Team Update 02

KitBot

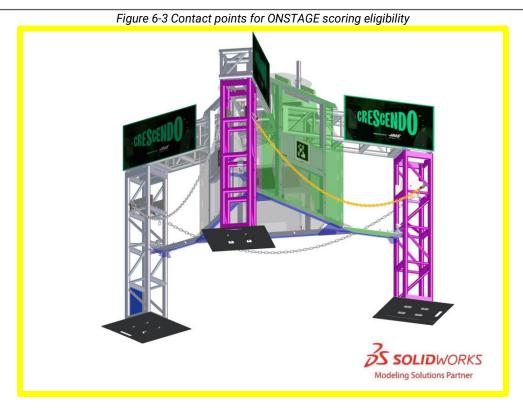
To qualify for ONSTAGE points, a ROBOT may only be contacting:

- their truss legs (pink shaded elements in Figure 6-3) via ROBOT BUMPERS,
- B. GAME PIECES.
- C. chain-facing vertical surfaces of their core or the nearest flap (with regards to the chain used by the ONSTAGE ROBOT, green shaded elements in Figure 6-3),
- D. carpet facing surfaces of their core (blue shaded elements in Figure 6-3), and
- E. a single STAGE chain (on their STAGE) (highlighted in orange in in Figure 6-3),
- F. another ROBOT qualified for ONSTAGE points,
- G. another ROBOT awarded the ENSEMBLE RP because of a G424 infraction, and
- H. an opponent ROBOT.

R409 *Fill BUMPER corners.

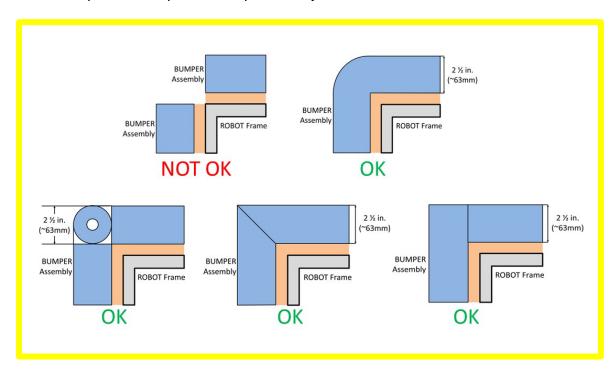
Figure 8-7 has been updated to improve conceptual clarity...
